Development Review Board Comments

Project Number: 1003393
Application Number: 04DRB-00601

Lots 12 through 16, Block 8, Enchanted Mesa

**CITY OF ALBUQUERQUE
PLANNING DEPARTMENT
Development Review Board
May 5, 2004
Comments**

PROPOSED
TOWNHOMES
CHELWOOD PARK
BLVD.

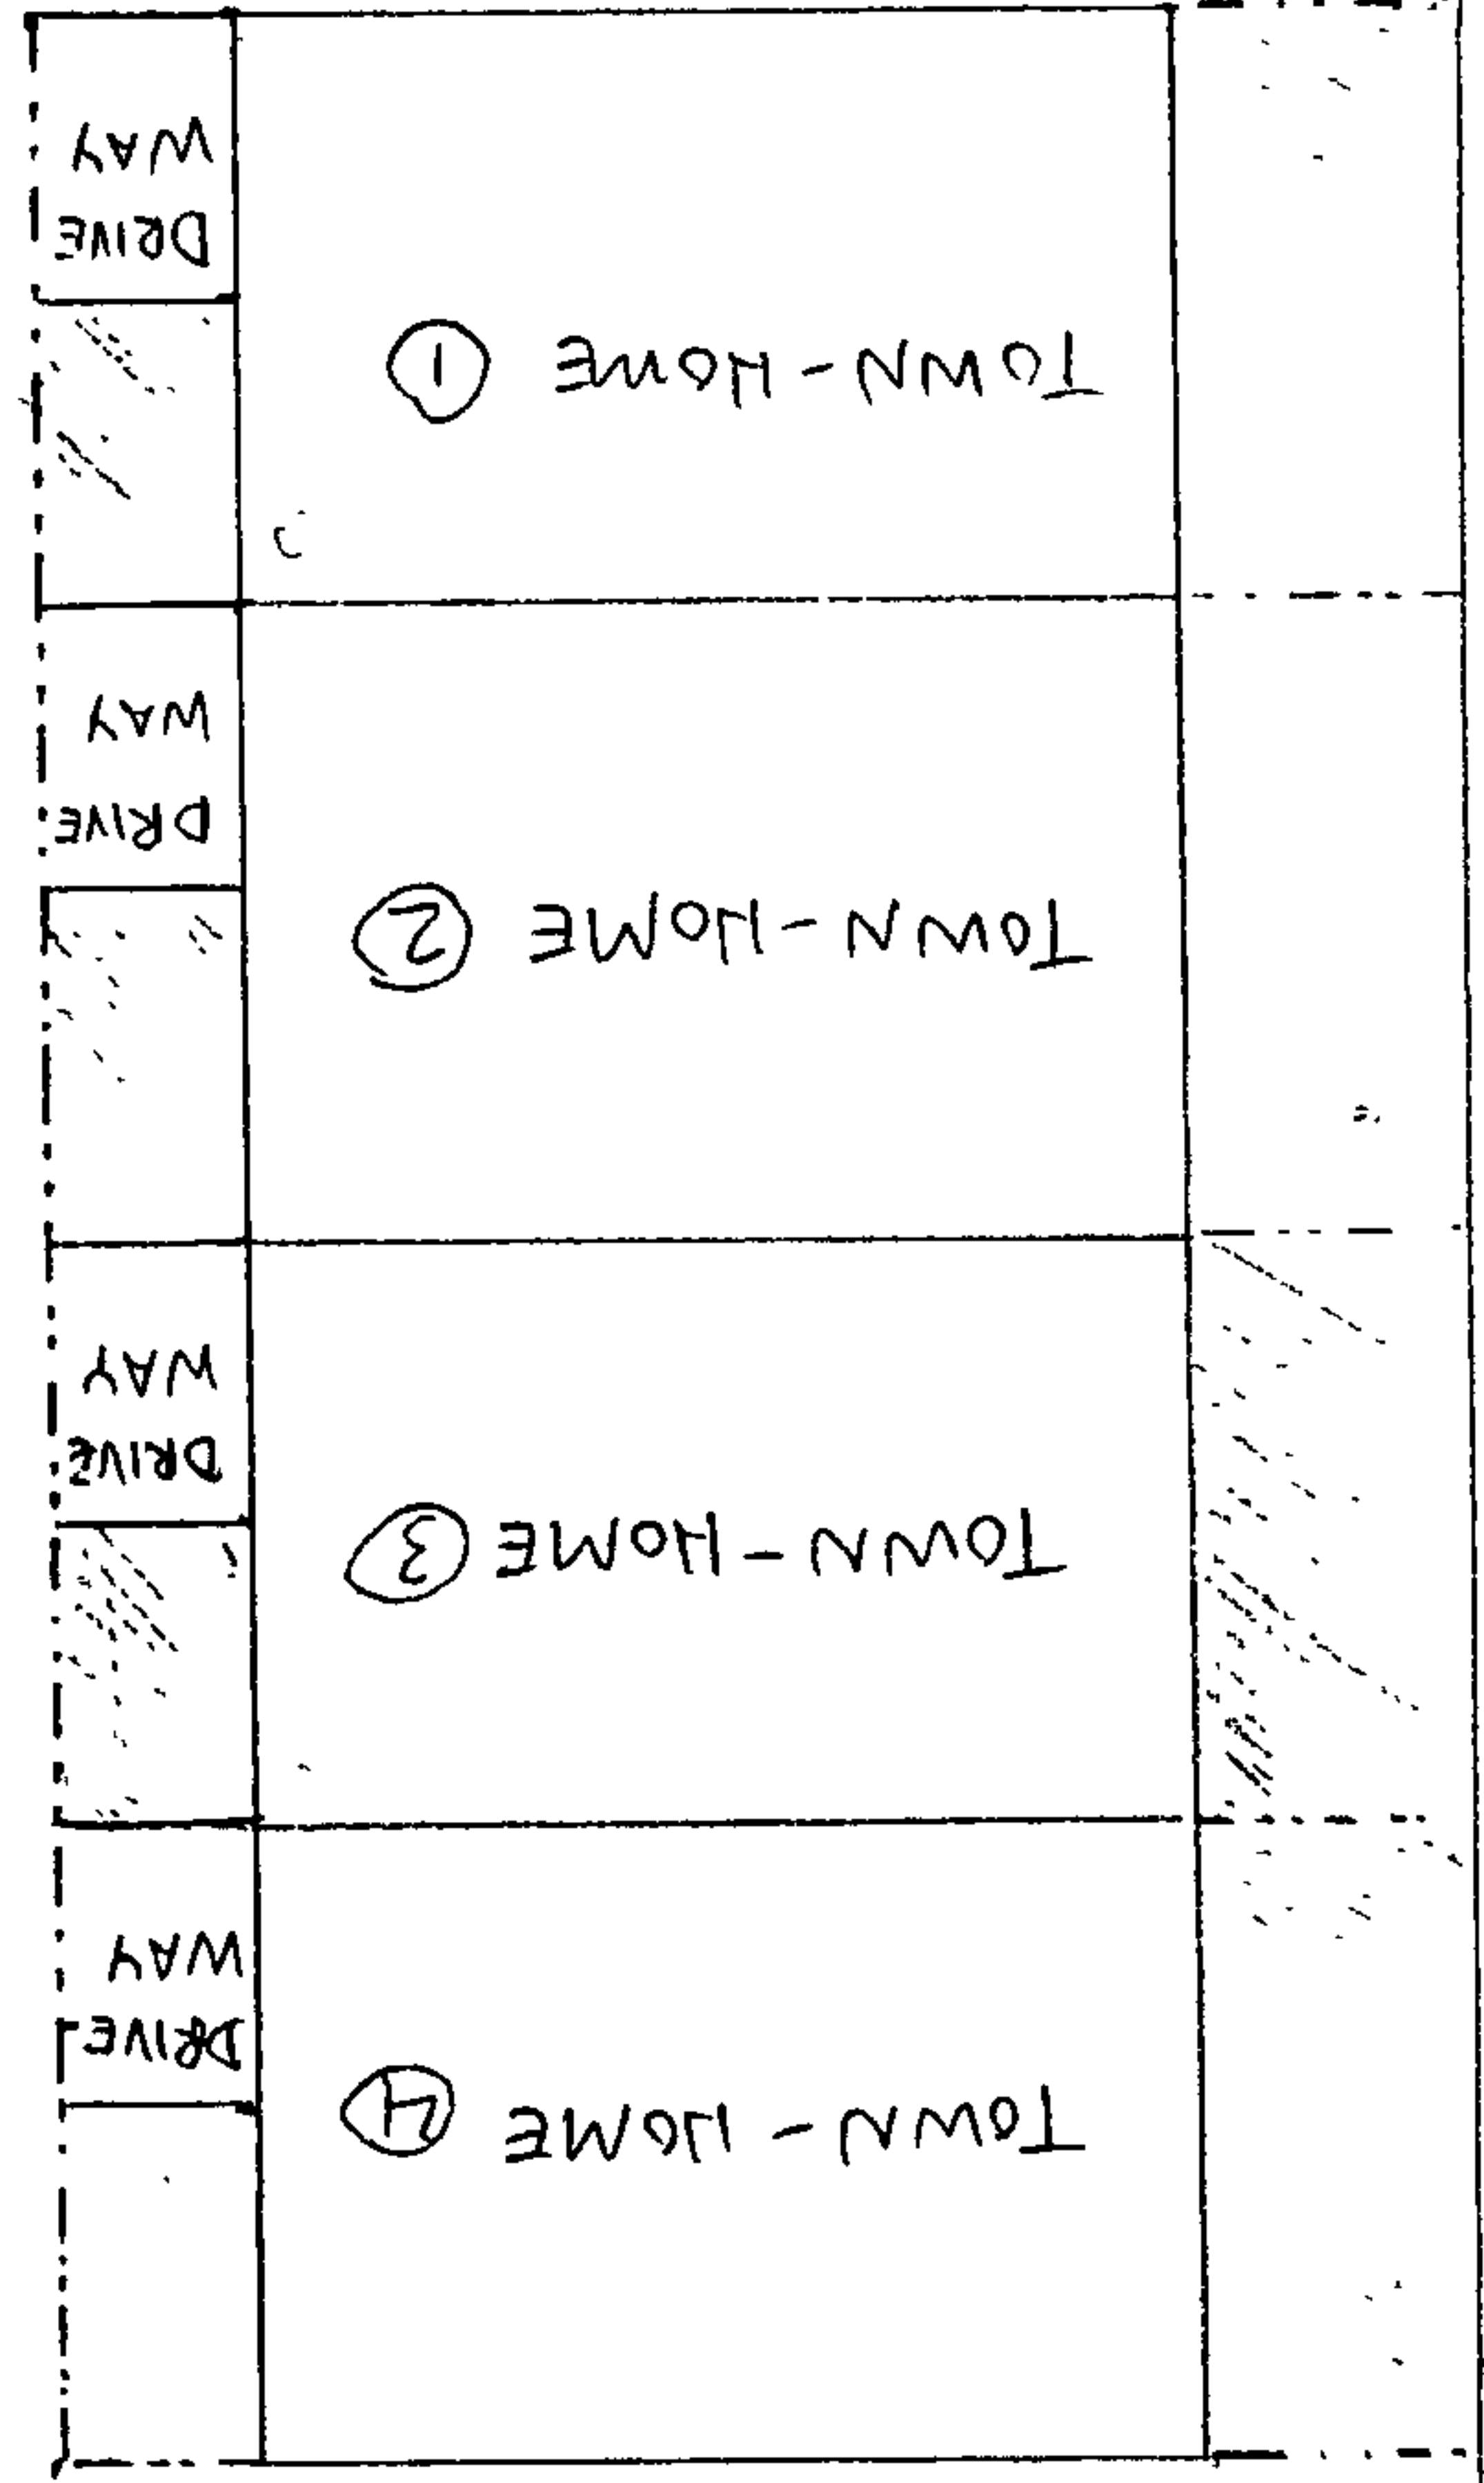
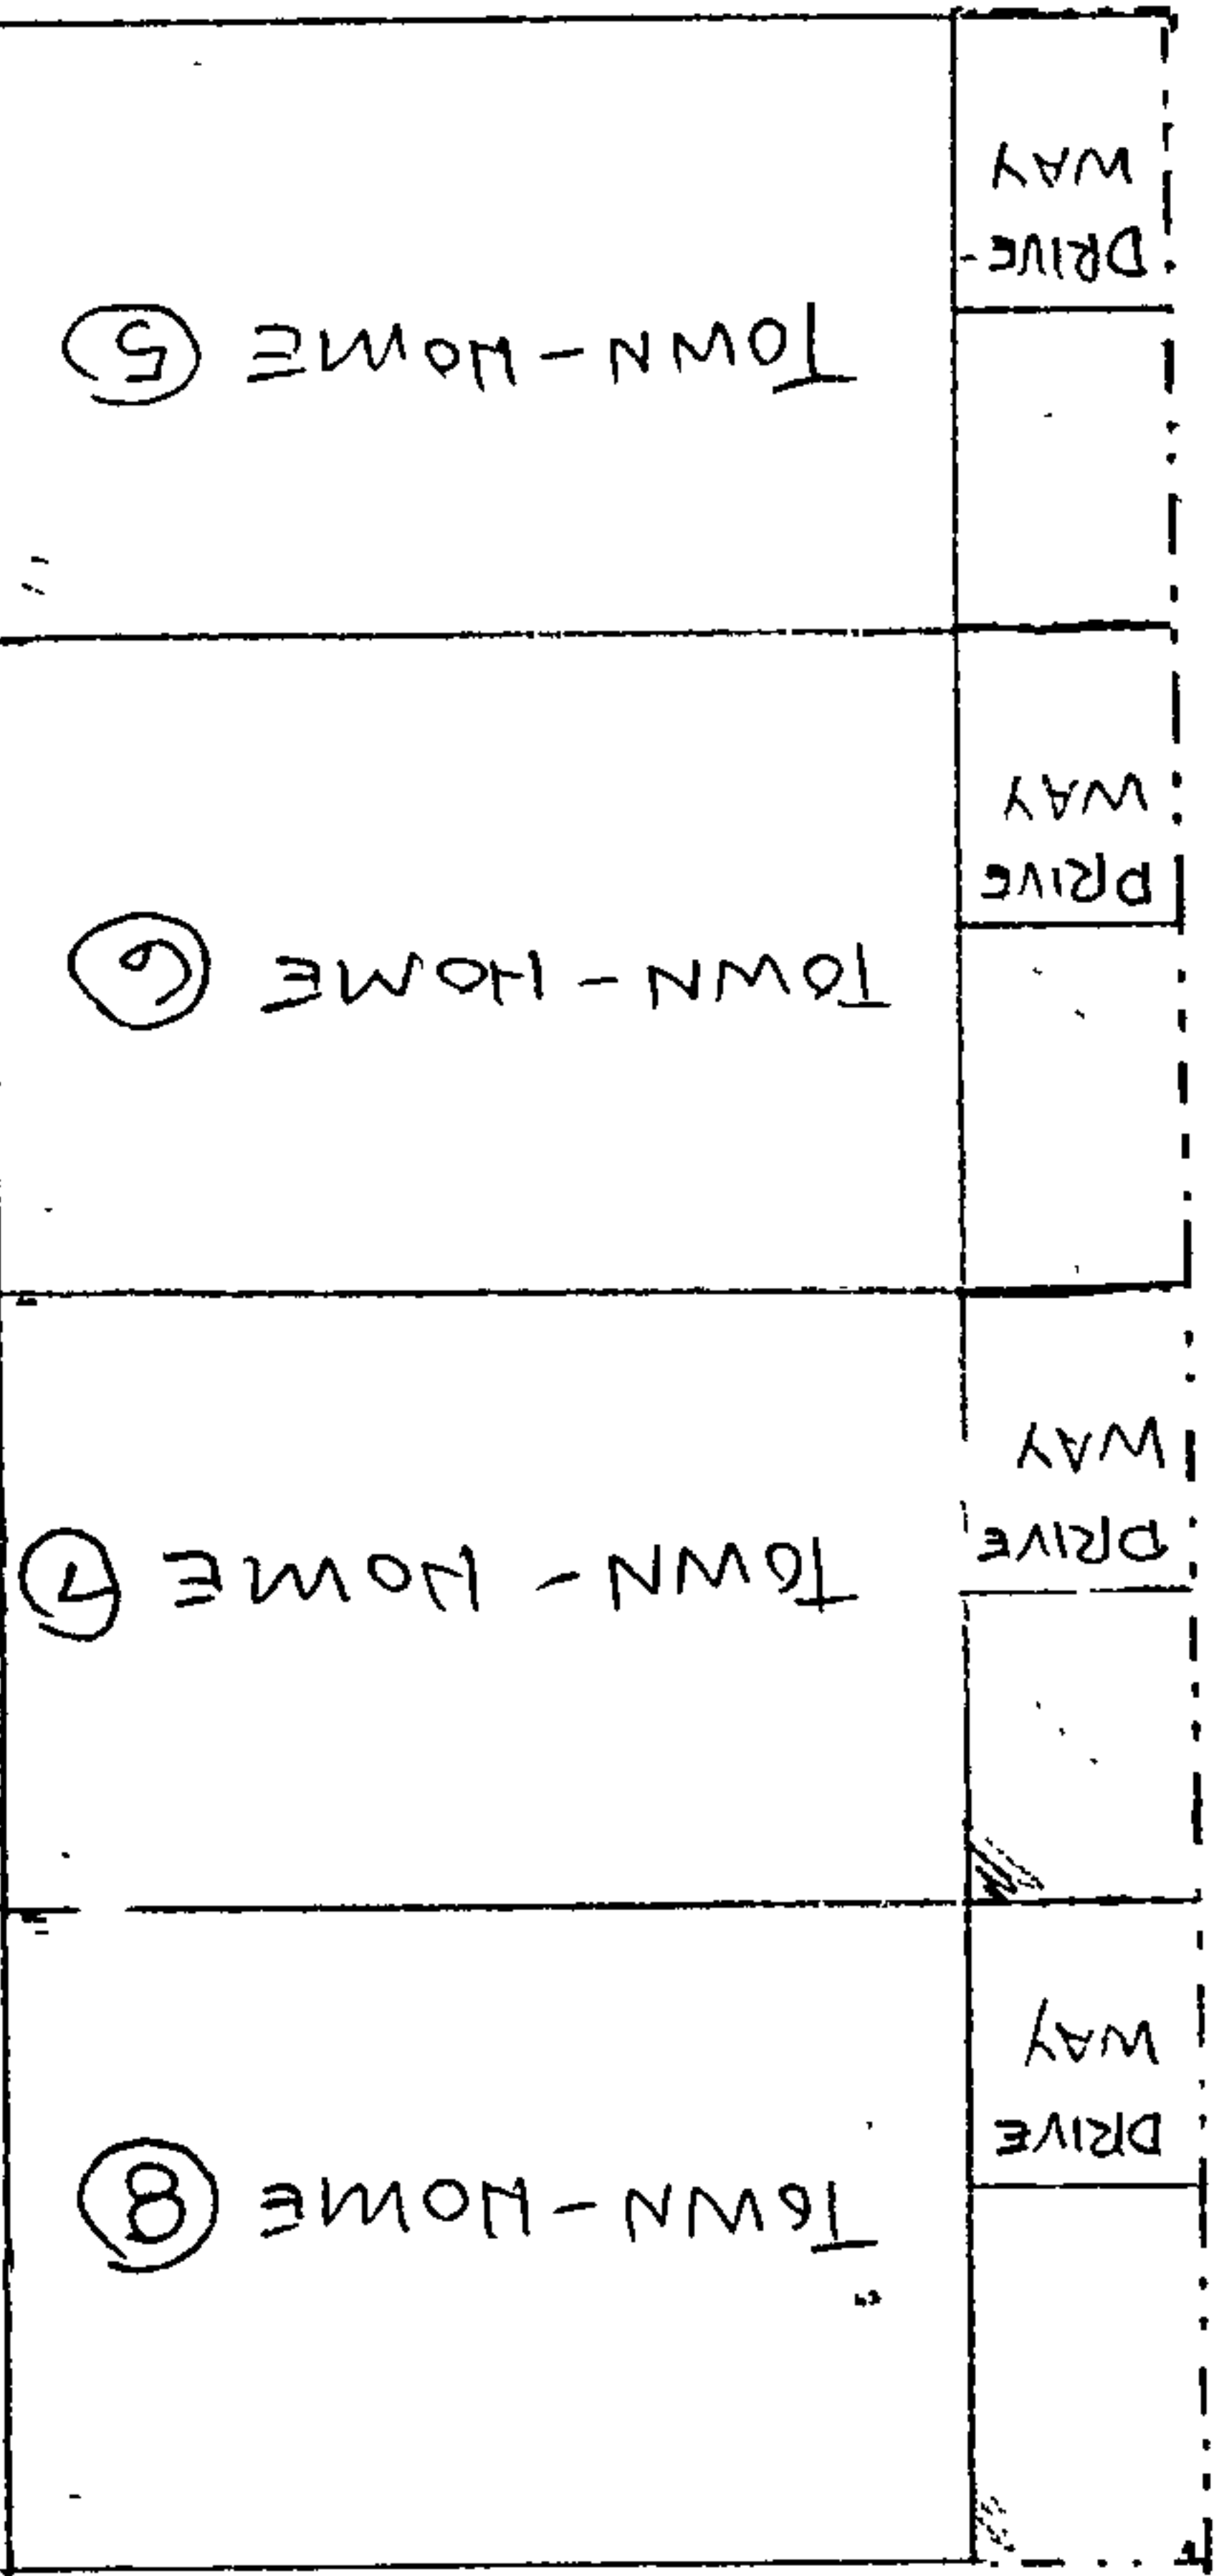
- 1) How wide is alley (20' min.) and is it paved?
- 2) Access road between units should be a minimum of 32' incl. 4' sidewalks. Is this a private road?
- 3) Is the current drivepad in place on Chelwood? Sidewalks? Provide x-section to verify if any right-of-way dedication is needed. (Chelwood requires bikelanes - collector) Sight distance also needs to be verified.
- 4) Is the common area to be owned and maintained by an association?

What are the current land uses surrounding this property?

Under the current C-1 zoning, townhomes are a conditional use. This means an application must be made to the Zoning Hearing Examiner to grant a conditional use.

Also, there are open space requirements for townhomes built on C-1 property. See Section 14-16-2-16
